NACIMIENTO WATER PROJECT
 ADDENDUM NO. 02
 for
 NWP FACILITIES
 CONTRACT NO. 300187.08-02
 SPECIFICATION No. 02

NWP NACIMIENTO WATER PROJECT

ADDENDUM

DATE:	August 1, 2007
PROJECT:	NWP Facilities
ADDENDUM NO.:	2
BID OPENING:	August 16, 2007

Sheet No.	Drawing No.	Sketch No.
40 of 179	A-C100	300187.08.02-SK28
Nacimiento Water Project NWP Facilities		
Contract No. 300187.08.02		
ADDENDUM NO. 2

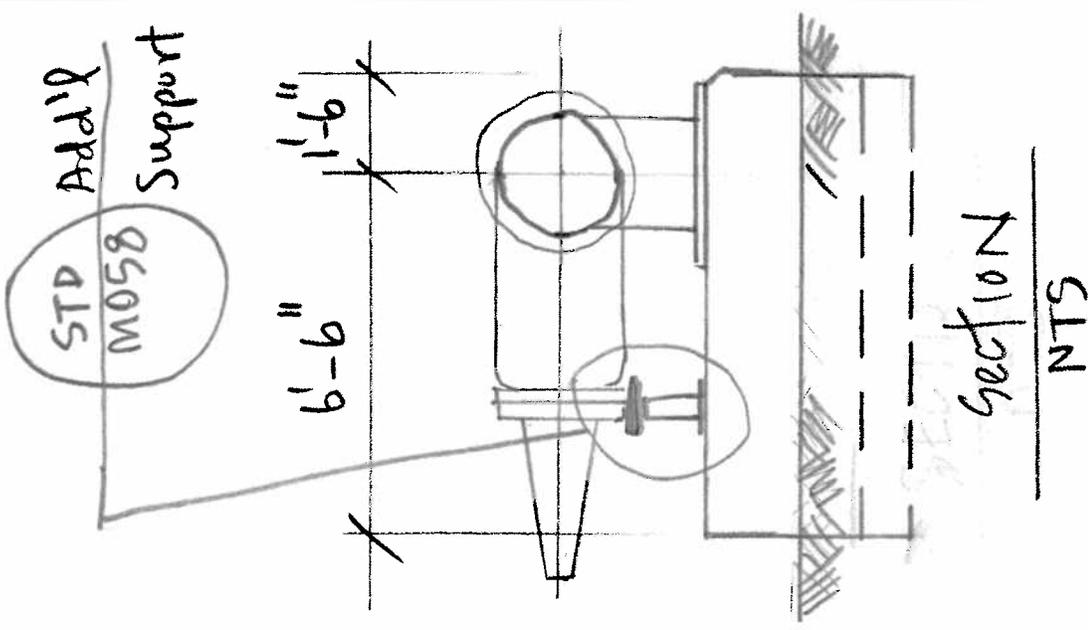
11. Drawing A-C100, Sheet 40 of 179; added expected limits of site excavation to be performed by the Intake Contractor as shown on Sketch 300187.08.02-SK28, attached.

Added expected limits of site excavation to be performed by the Intake Contractor

Sketch No.
300187.08.02-SK29

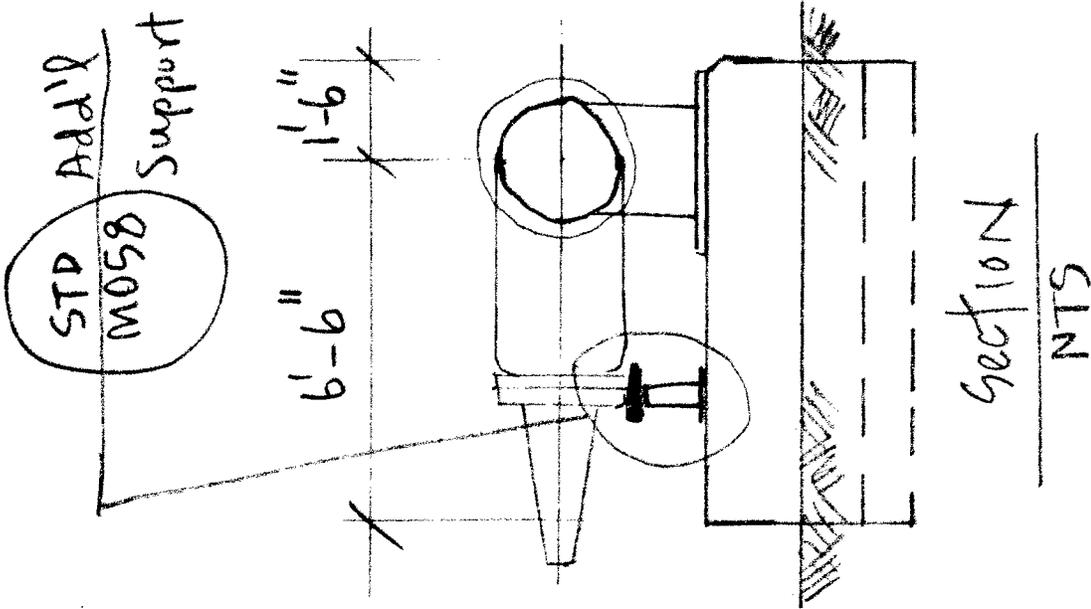
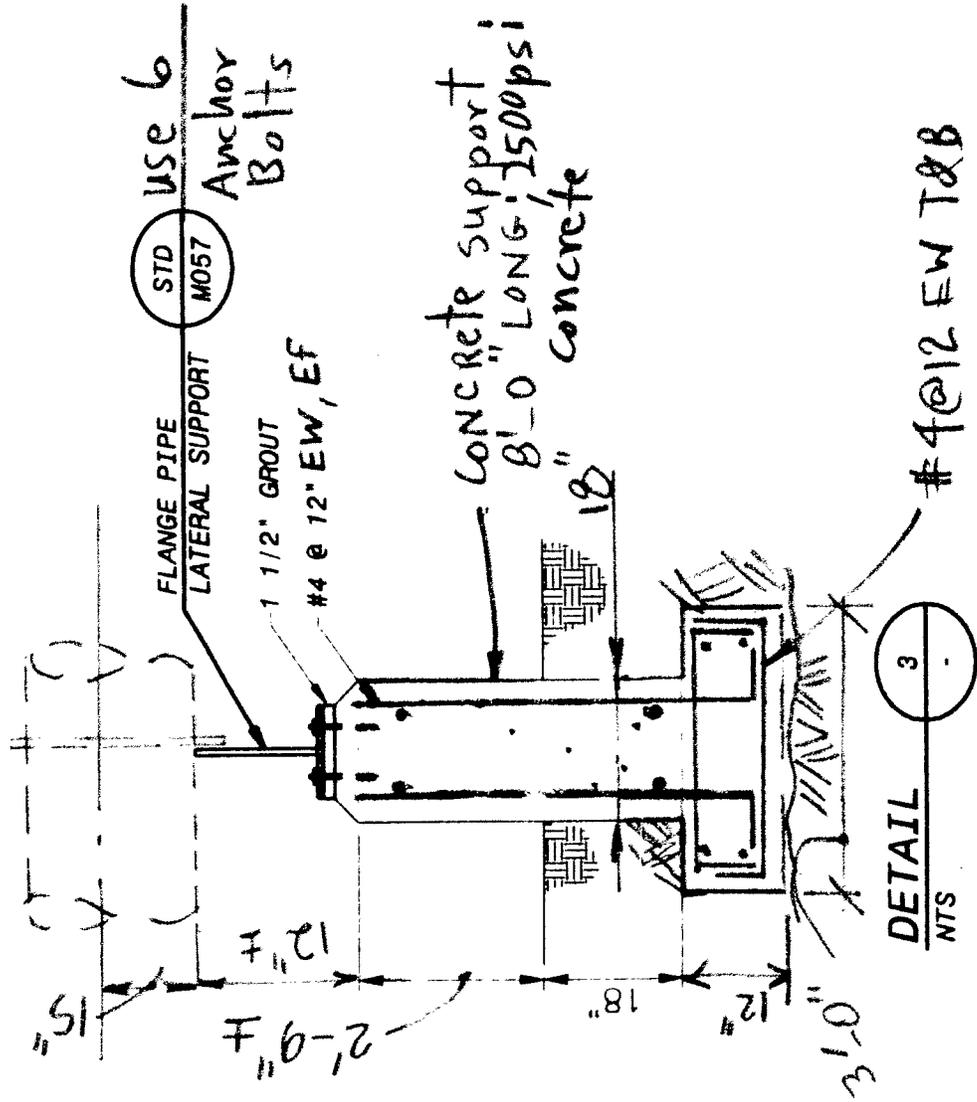
- In Detail C, revise the brass box callout to read: “12” SQUARE BRASS BOX WITH FLUSHED-MOUNTED HINGED LID”
16. Drawing A-C301, Sheet 44 of 179; replace existing Detail 3 with larger pipe support system as shown on Sketch 300187.08.02-SK29.

Modified Gate Valve Support Detail
